SUBJECT: POTENTIAL CORE SHROUD CRACKING AT BOILING WATER REACTORS

NRC INFORMATION NOTICE 93-79: CORE SHROUD CRACKING AT BELTLINE REGION WELDS
IN BOILING-WATER REACTORS

CORE SHROUD CRACKING
PRELIMINARY SAFETY ASSESSMENT

FIGURE 1
BWR REACTOR VESSEL

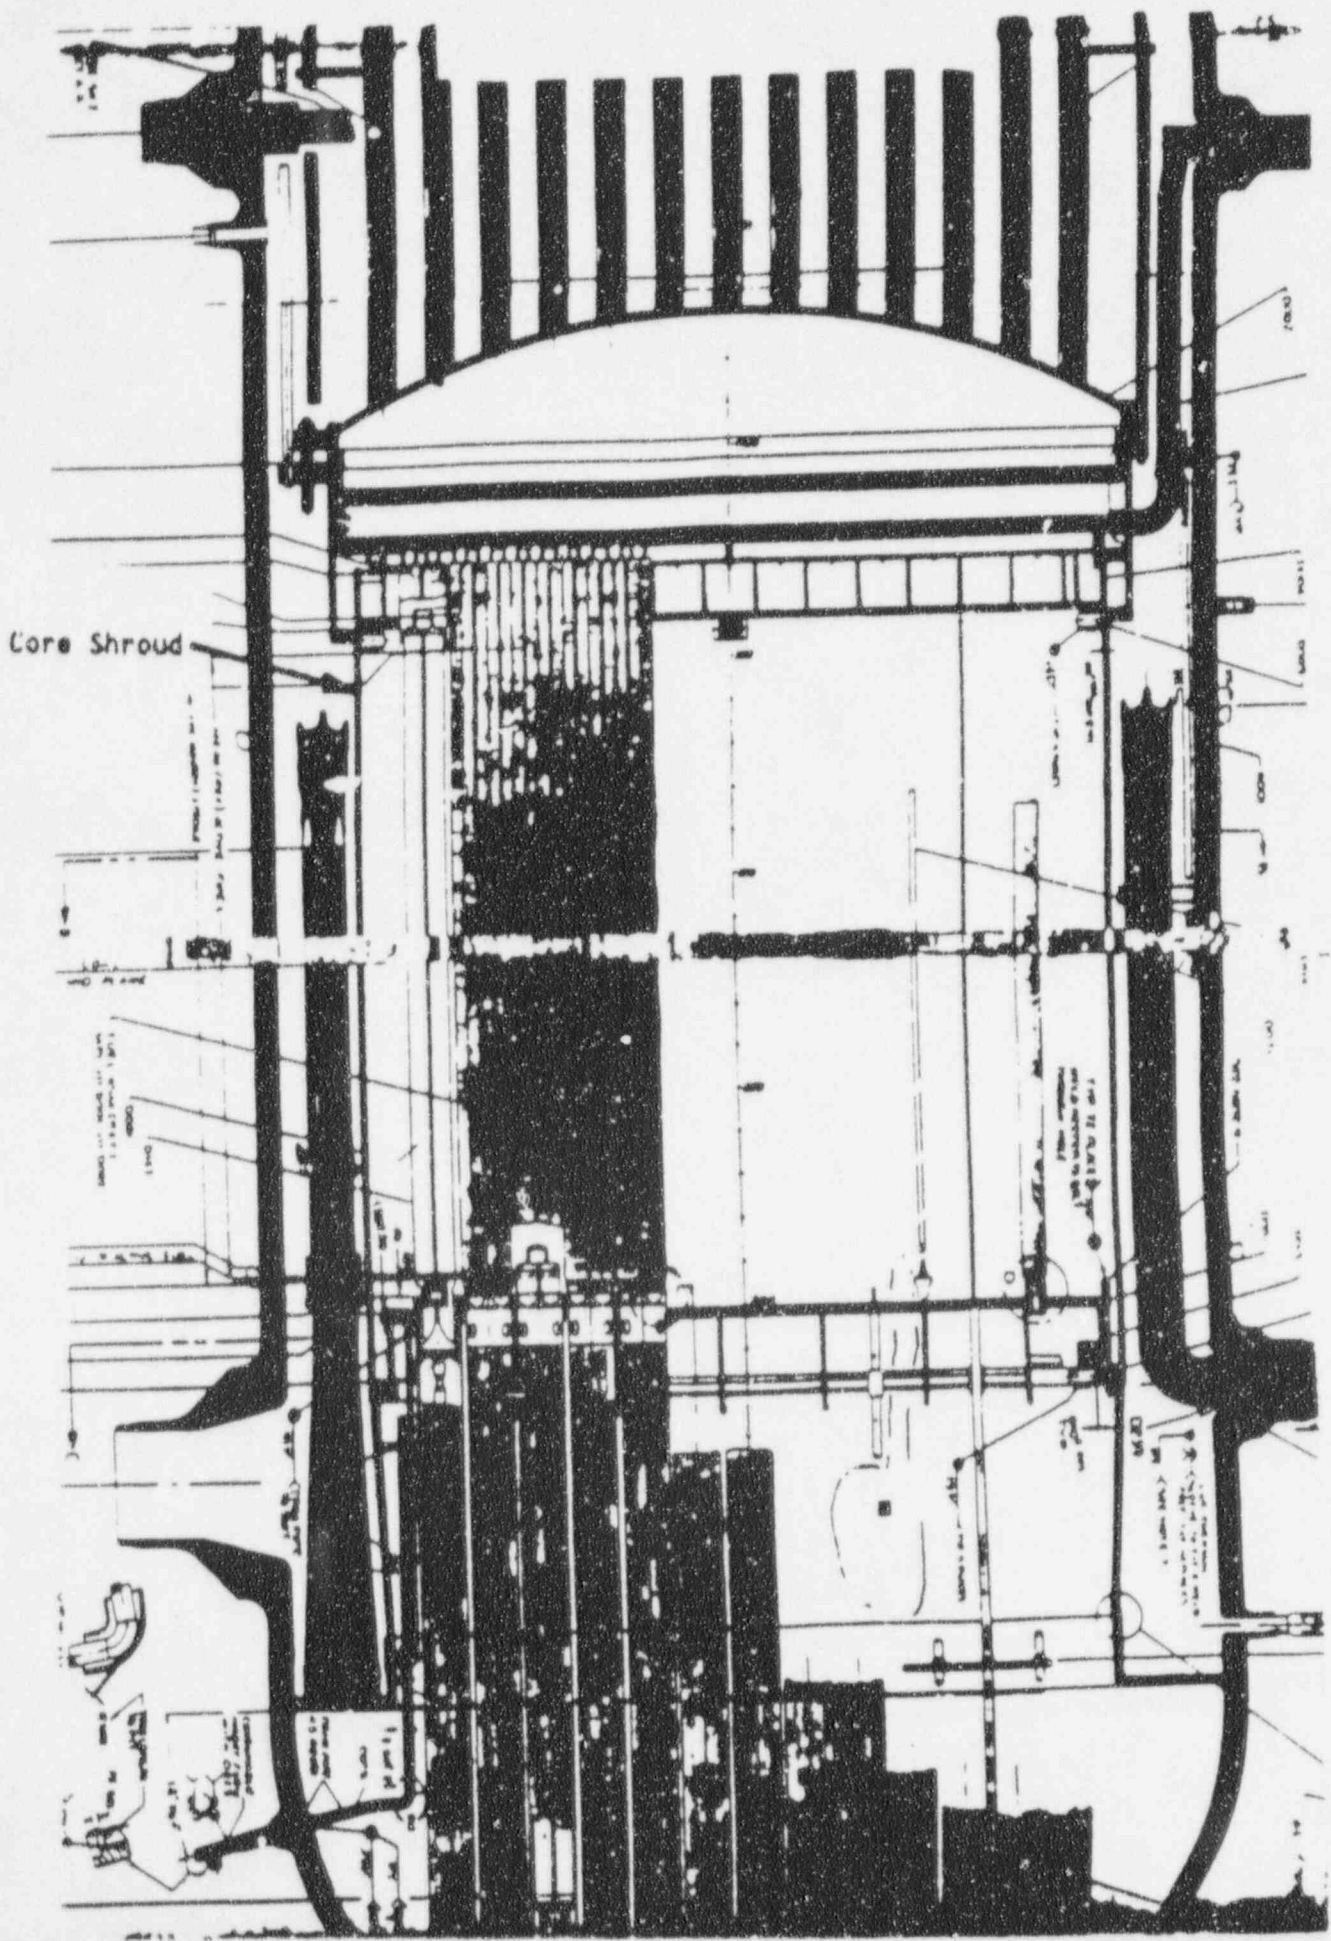
The core shroud is illustrated in Figure 1. The core shroud separates the core region from the downcomer annulus, which contains the jet pumps, and assures that feedwater flow is directed down the downcomer annulus, through the jet pumps, through the lower plenum, and up through the core region. From the core region, the exiting two-phase flow is directed through the steam separators and dryers and the steam then exits the vessel through the steam lines while the liquid is recirculated to the downcomer annulus. The core shroud is welded at the bottom to the ledge at the bottom of the downcomer annulus upon which the jet pumps sit. The shroud is further supported by 14 pedestals welded to the bottom head of the reactor vessel. The steam separators and the dryers are mechanically attached to the core shroud at the ledge region near the top of the core above the core spray spargers. The core top guide structure, which provides lateral support for the fuel assemblies and assures that the core geometry is maintained to allow for control rod insertion, is supported by a second ledge below the core spray spargers. The spray header for the high pressure and low pressure core spray systems is contained within and supported by the core shroud and the connecting piping enters through the vertical portion of the core shroud above the top guide support ring (ledge).

Figure 2. Weld and Plate Locations in the Beltline Region of the Brunswick Unit Core Shroud (From CP&L)

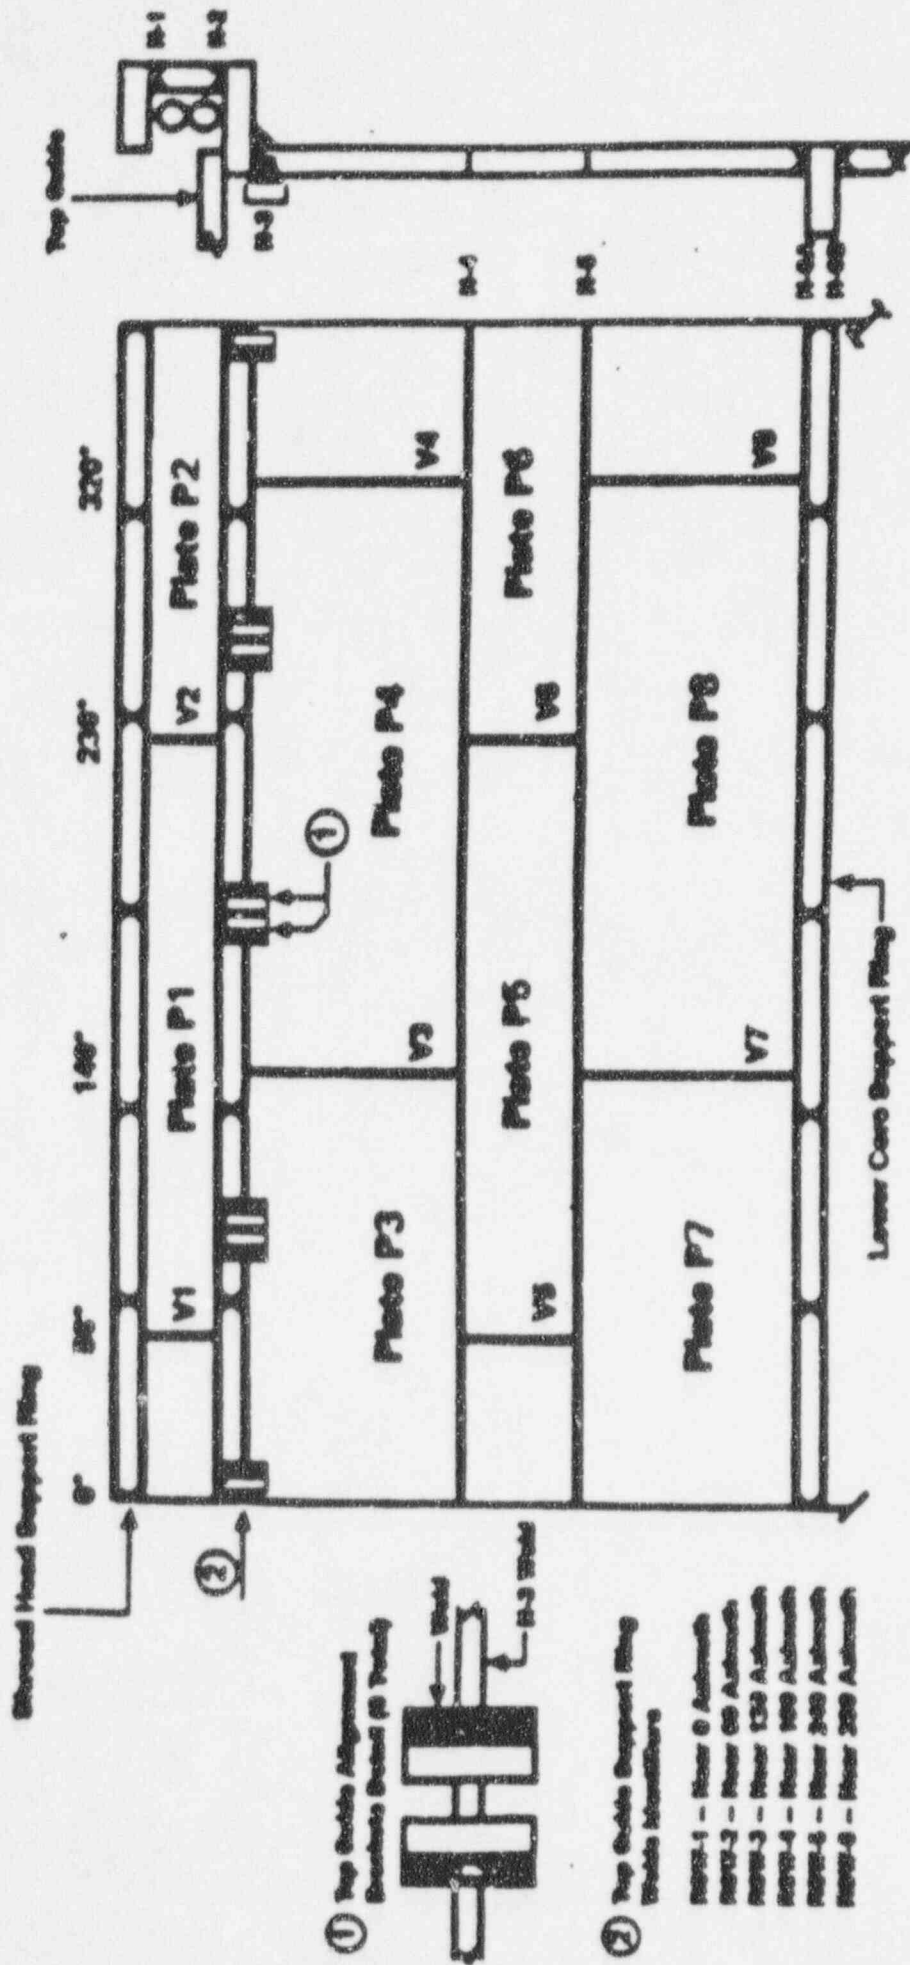
The specific cracking observed at Brunswick Unit 1 is illustrated on Figures 2 and 3. Numerous cracks were observed in the lower elevations of the vertical portion of the core shroud surrounding the core. These cracks predominantly ranged from one to three inches in length, with several longer cracks of 9 and 30 inches in length. None of these cracks penetrated through the shroud wall. A 360° circumferential crack was observed at weld location H3 which connects the upper ledge of the core shroud to the vertical portion of the core shroud which surrounds the core. At this location, the weld thickness is 2.25 inches. Using UT, the crack depth was found to range from 0.8 to 1.7 inches.

Figure 3. Details of Welds and Cracks at Weld Locations H-2 and H-3 in the Brunswick Unit 1 Core Shroud (From CP&I)

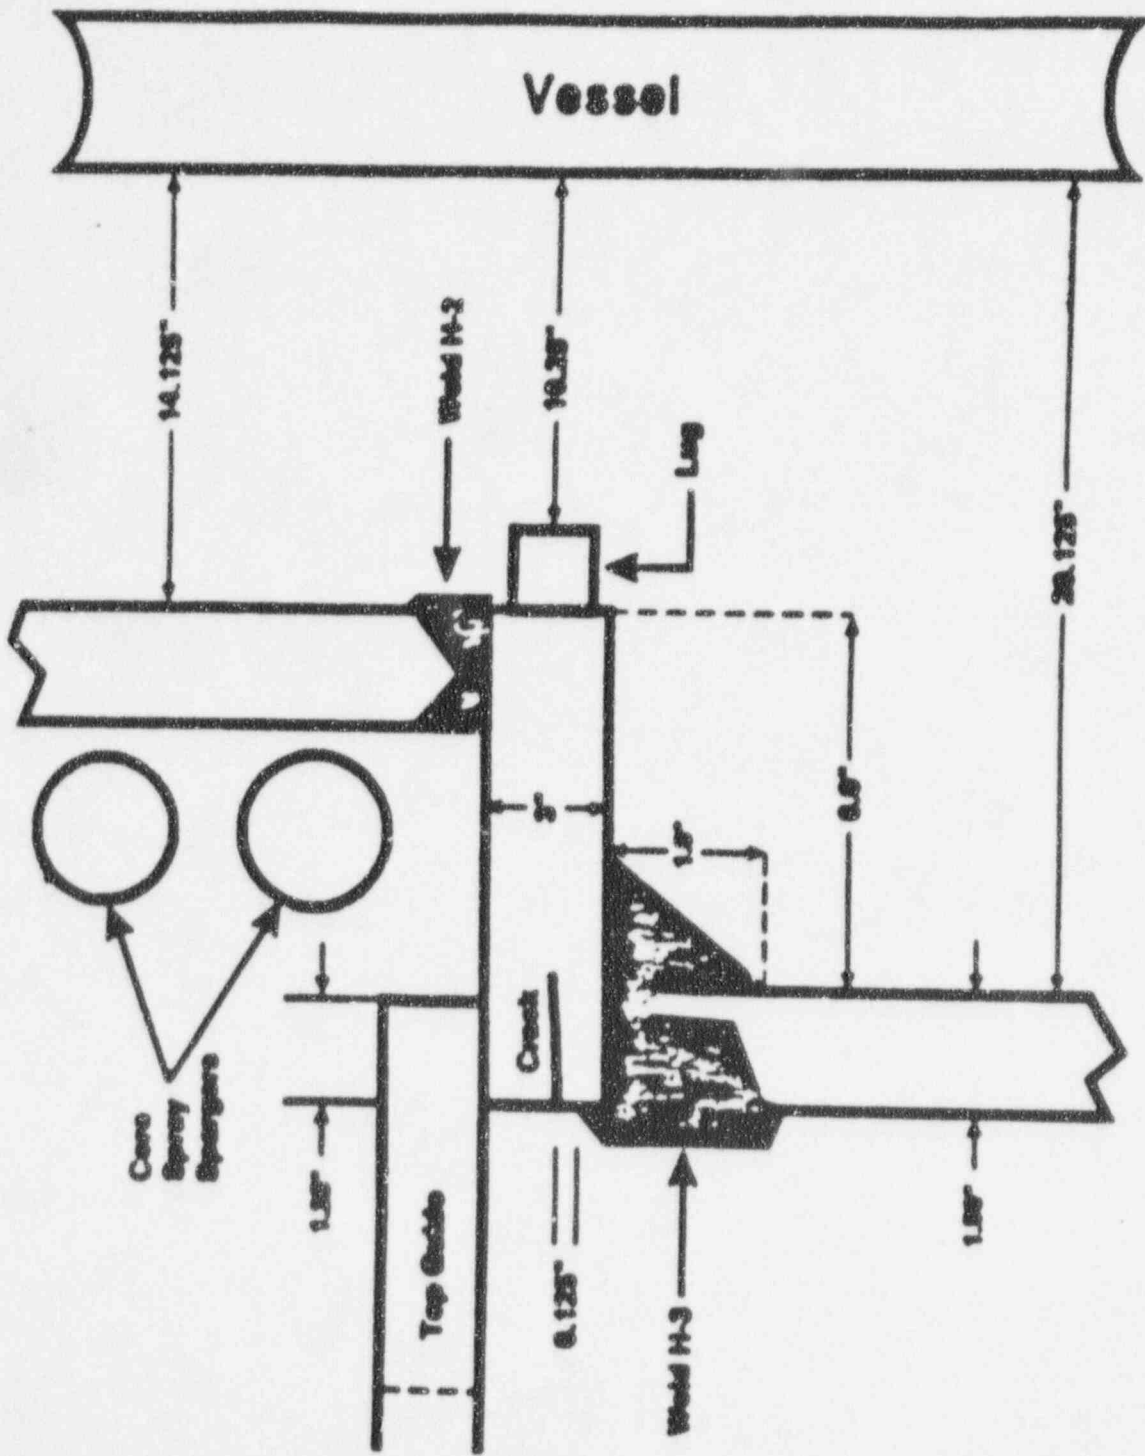
With respect to the cracking observed at the H3 weld location, the licensee has evaluated the structural integrity of this weld under normal operation, accident, and earthquake conditions. The licensee has estimated that if a $\frac{1}{4}$ inch ligament remained around the circumference, the structural margins, including an allowance for crack growth, required by the ASME code would not be exceeded. Therefore, the licensee concluded that the as-found cracks would not impair structural integrity and were not safety significant.

The staff does not believe that sufficiently conservative margins of strength will remain for an additional operating cycle. Additionally, the staff felt that the UT examination was not sufficiently accurate in its indication of crack depth.

The licensee has elected to perform a repair that will provide the

structural requirements for the attachment of the top guide support ring to the lower core shroud. Specifically, the licensee is evaluating structural stiffeners to compensate for the loss of margin in the structural integrity of the H3 weld. In addition, the licensee will start up with H₂ water chemistry (20 scfm) which will reduce the growth rate for the IGSCC cracks and reduce the potential for future crack development. The staff will continue to evaluate the licensee's repair actions.
